**Re: Project, Permit No. M-1980-244;  
Third Adequacy Review, Amendment Application (AM-13) Response to Comments**

## THIRD ADEQUACY REVIEW COMMENTS AND RESPONSES

<b>SGOSA Stability Analysis</b>			
	<i>Analysis Description</i> Section 4 - With Ore - Static - Local Failure			
	<i>Drawn By</i> JJS	<i>Scale</i> 1:2000	<i>Company</i> Cripple Creek and Victor Mine	
	<i>Date Printed</i> 12/17/2020	<i>File Name</i> SECTION 5 STABILITY.slmd

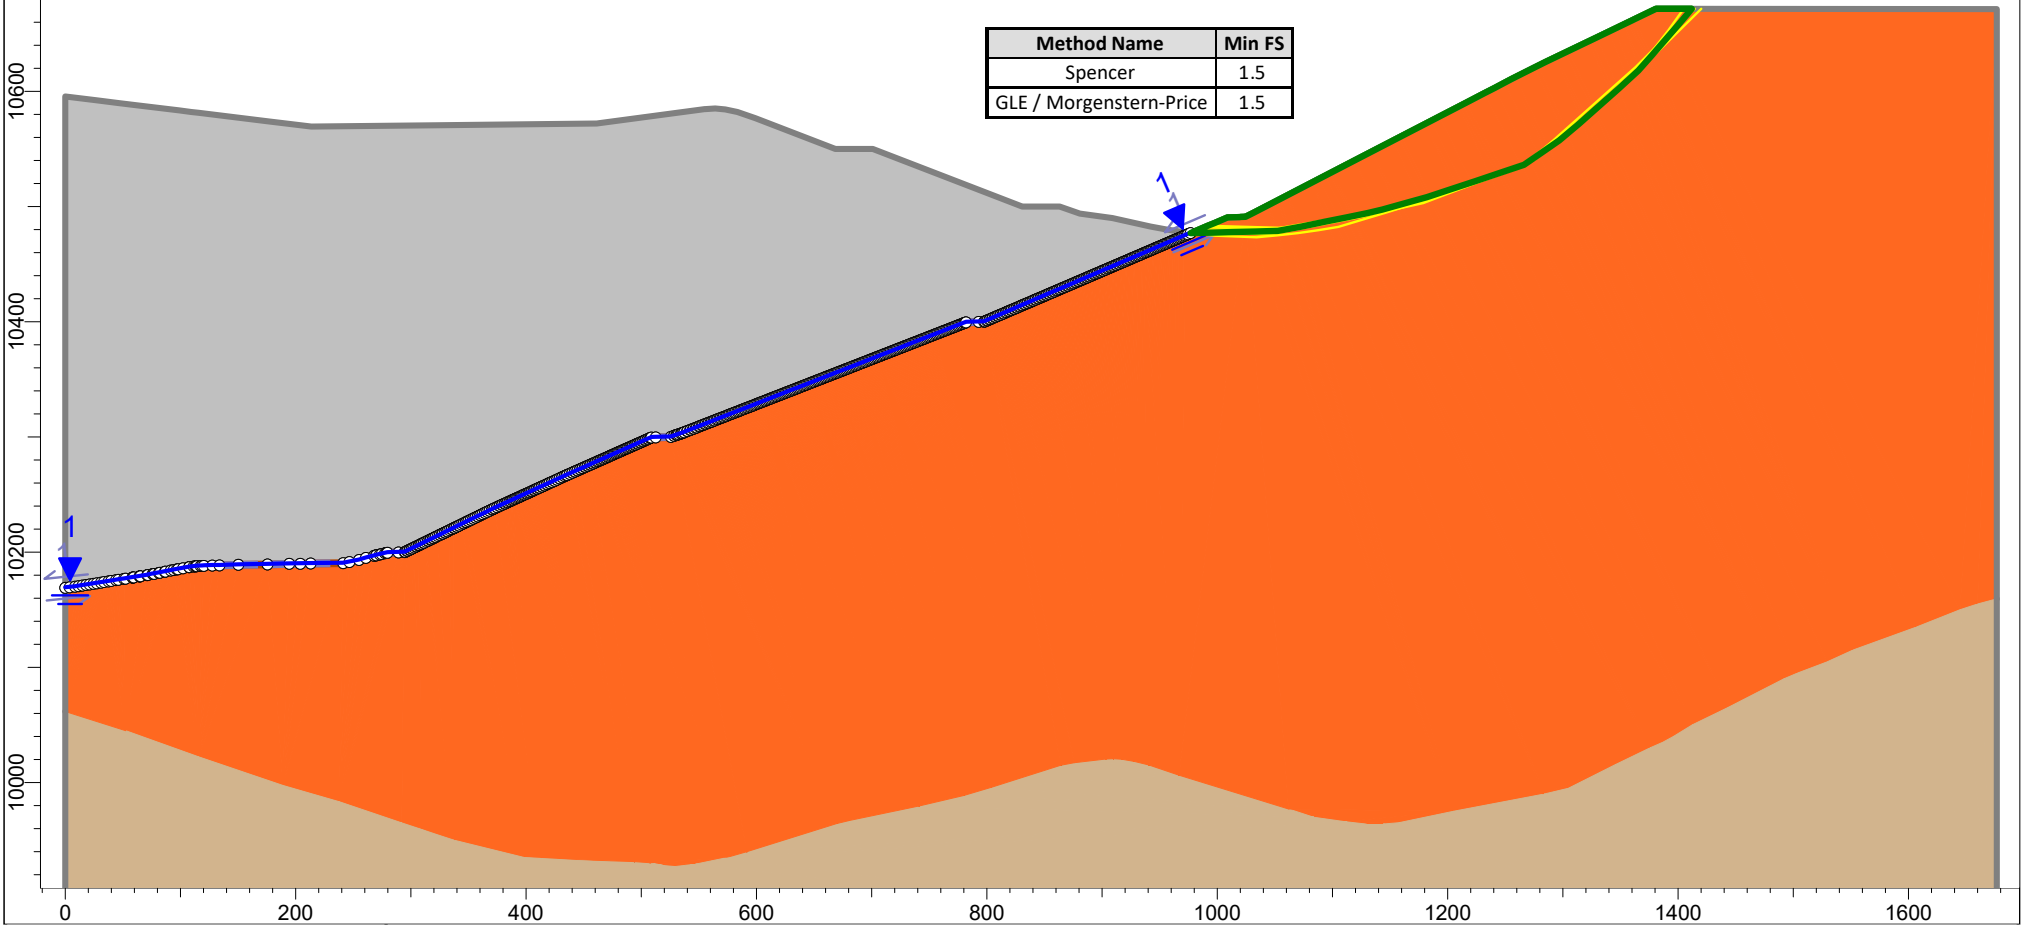
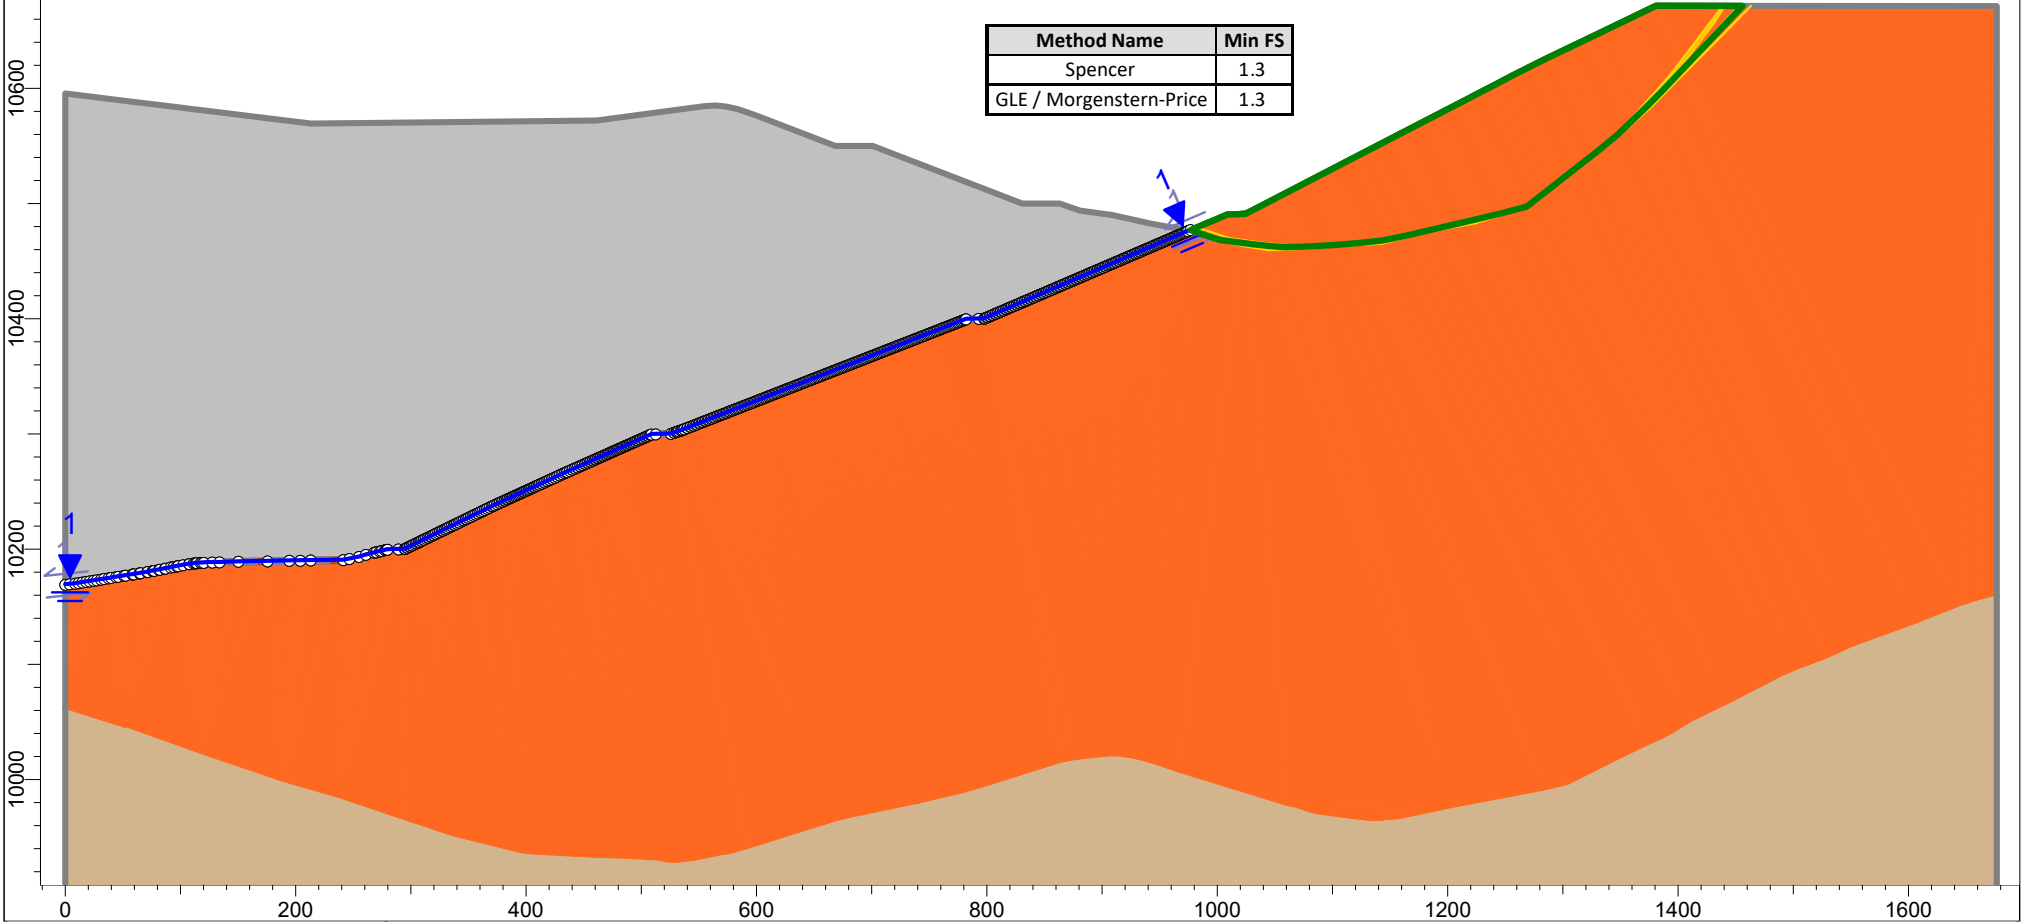
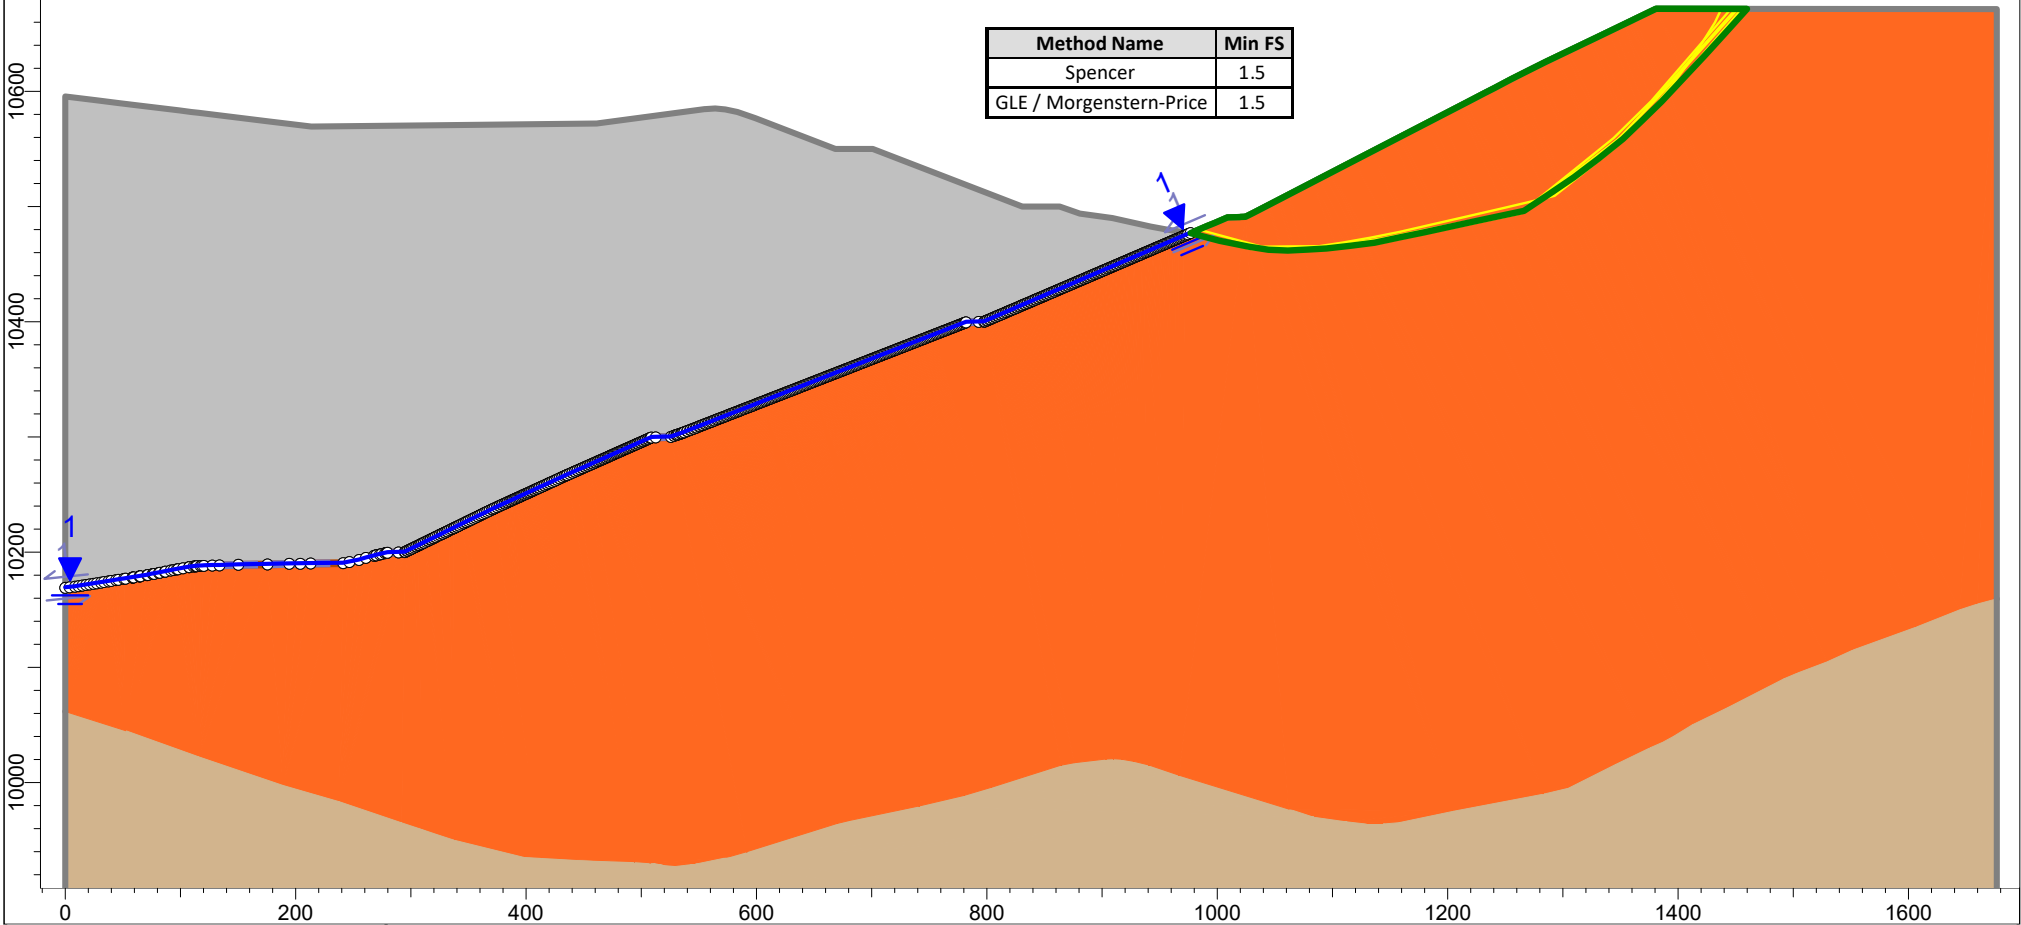
*C. The response requires additional clarification or a revision. The response cites a sensitivity analysis for Section 1 indicating the FoS remains at ~2.015 for all angles of friction analyzed. However, the slope stability analyzed for the north end of Section 1 in the April Preliminary Adequacy Review (PAR) response shows the FoS = 1.4 (see Attachment 1 for Comment C). In addition, all failure surfaces for the north end of Section 1 are in the pit backfill material (see Attachment 1). The same is true for Section 4 in the PAR response. It is implausible that varying the friction angle in Sections 1 or 4 has no effect on the stability. (Note: The DRMS acknowledges the analysis for Sections 2 and 3 support the argument made in the Second Adequacy Review response, as the failure surfaces do not intersect the pit backfill material.) Please explain why varying the friction angle in material for which your analyses demonstrates failure surfaces does not affect the FoS; or revise the designs for Sections 1 and 4 to meet the required FoS (for static conditions  $\geq 1.5$  and for seismic conditions  $\geq 1.3$ ).*

Please refer to CC&V's response to Comment C provided in the previous response to comments. The following is a background summary of A-13 stability evaluations presented:

- ii. The calculated factor of safety was presented as 1.4 and 1.2 for static and pseudostatic conditions, respectively.
- 2) The revised design report (NewFields, July 2020, Rev. 1): Presented a stability analysis for Section 1 and adding in an evaluation of Section 4, enclosed as Attachment 6.

- 3) The responses provided to DRMS in the November 2020 PAR included additional stability evaluations.
  - a) Section 1 stability evaluation was modified to force the failure surface through the VLF and not along the underlying Schist Island Pit backfill. The SLIDE model output results for Section 1 and the new critical failure surface are provided in Attachment 6.

failure surface presented in the Design Report (Rev. 0 and Rev. 1) were not significant enough to compromise the integrity of the VLF liner system or overall stability. In general, the presented failure surface along the backfill slopes are veneer failures that are: (1) a function of how the shear strength is modeled using the Mohr-Coulomb failure envelope, and (2) generally veneer failures are operational concerns and not indicative of global instability. The revised Phase 1 stability evaluation is considered more appropriate to assess true global slope stability, and indicates that this section of the facility is quite safe. The calculated factor of safety was presented as 2.0 and 1.7 for static and pseudostatic conditions, respectively.

- b) The new critical failure surface identified for Section 1 was then evaluated using a sensitivity analysis, which was provided in the text of the response to Adequacy review Comment C in the November 2020 submittal. The results of that sensitivity analysis, a plot of Factor of Safety v. Friction Angle, is also provided in Attachment 6.

- c) Section 4 stability evaluation is identical to the Revision 1 submittal (NewFields, July 2020).
- 4) In conclusion:
- a) Global stability of Section 1 is acceptable because the global stability analyses performed have been updated to (i) screen out results that reflect how the model uses the failure envelope (as mentioned above, and discussed in detail below) and (ii) screen out results associated with general veneer failures that are not indicative of global stability. The calculated factors of safety for the stability analyses are 2.0 and 1.7 for static and pseudostatic conditions, respectively.

- b) Veneer style failures of the Schist Island Pit Backfill (e.g. below VLF2 Phase 3 in Section 1) or the regraded SGOSA slopes (e.g. above VLF3 Phase 3 in Section 4) are primarily a function of how we model shear strength of these materials with Mohr-Coulomb failure criteria ( $\tau = \sigma_n \cdot \tan\phi + c$ ). If we model these materials as purely friction (i.e. cohesion is zero), then the shear strength ( $\tau$ ) is only a function of the normal stress ( $\sigma_n$ ) along the potential failure plane. Very thin failure planes, such as the veneer failures, have very little normal stress along the potential failure plane and thus the modeled shear strength is very low. This tends to drive the factor of safety down and geotechnical software will calculate this as the lowest factor of safety. This phenomena is generally controlled by the evaluating engineer using judgement on what constitutes significant slope movement that can compromise containment or global stability.

CLIENT	CRIPPLE CREEK & VICTOR GOLD MINING COMPANY	
	PROJECT	VLF2 PHASE 3	
TITLE	VLF CROSS SECTIONS (SHEET 1 OF 2)		FILENAME
	DRAWING NO.	A13	REVISION
			2

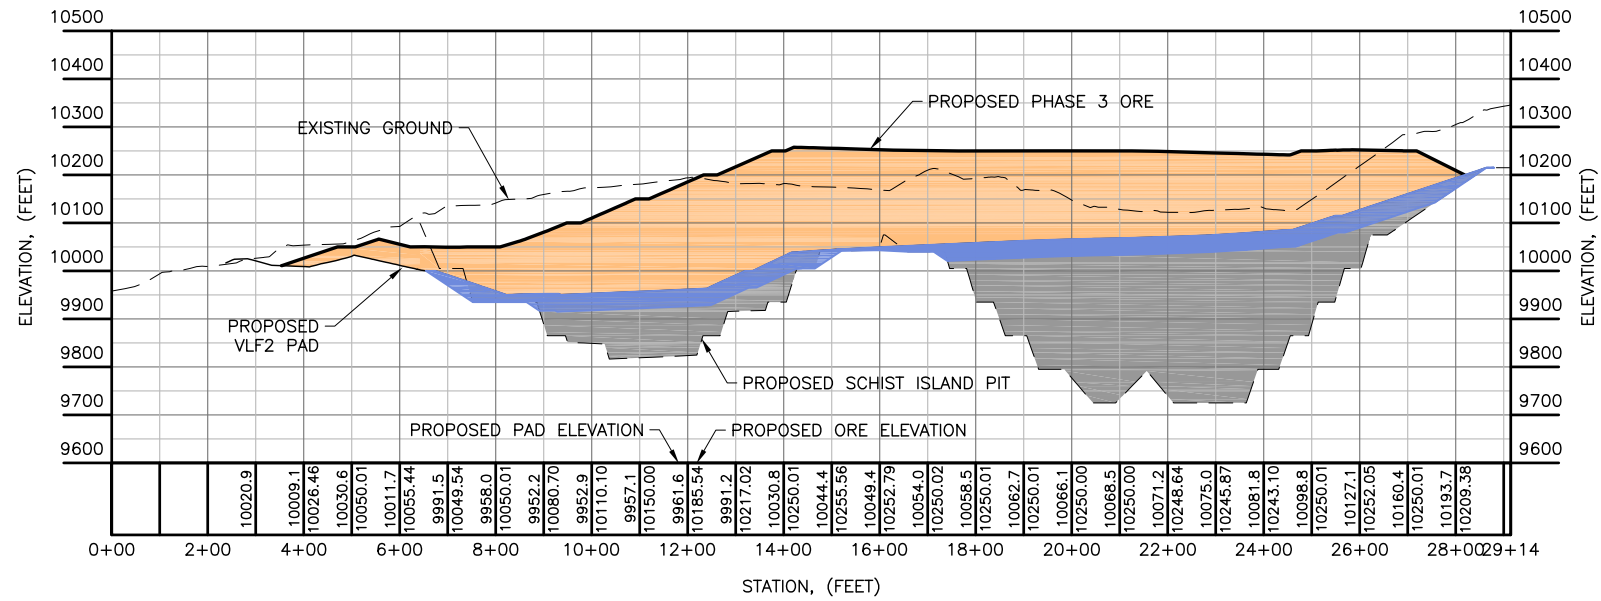
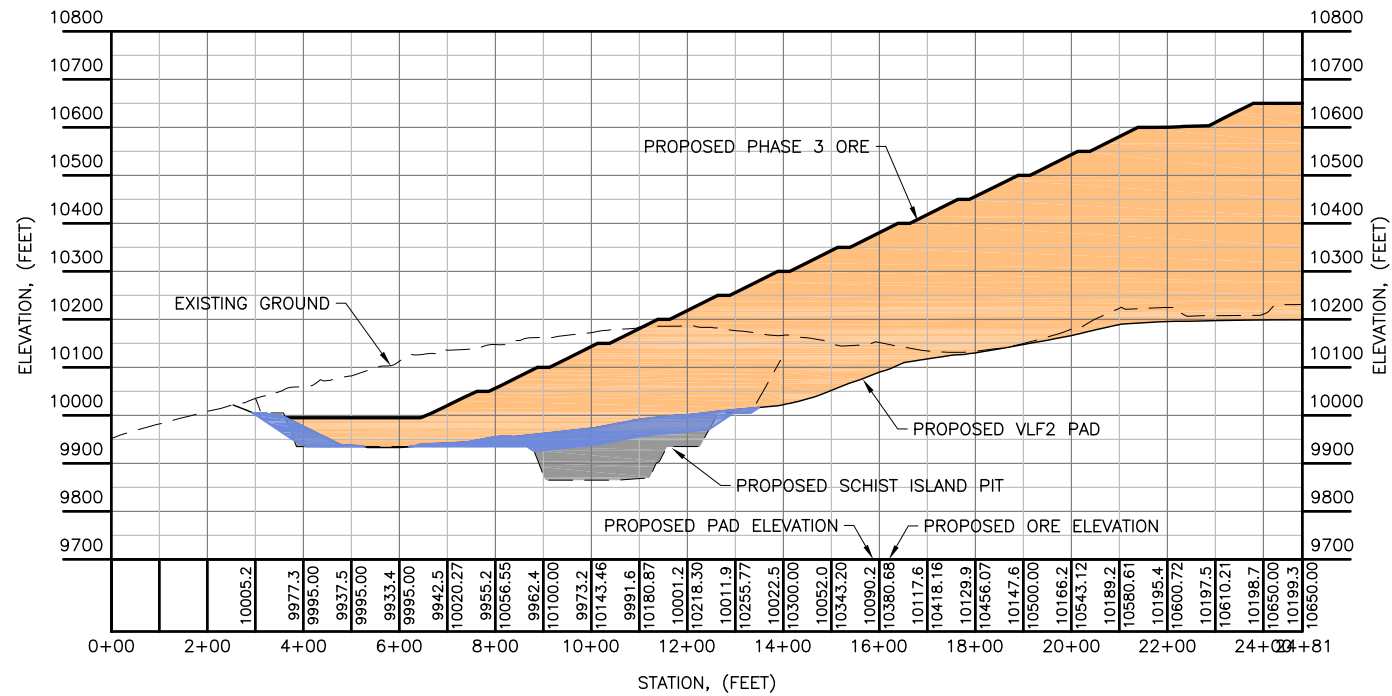
*VL2 Phase III Design Drawings A-13, A-14, A-19 and A-20. No formal comment issued. As discussed during a 21 December conference call with CC&V. Please update Drawings A13, A14, A19, and A20 to include additional detail specifying ore, structural fill, and overburden fill material.*

During a 21 December teleconference call with Division representatives, the Division indicated to CC&V that design Drawings A13, A14, A19, and A20 should be updated to reflect the different materials that would be used for pit backfill per the specifications and intent of the design. CC&V has updated those design drawings to show overburden backfill and structural fill materials that will be used to construct the pit backfill. The updated drawings are enclosed in Attachment 7.
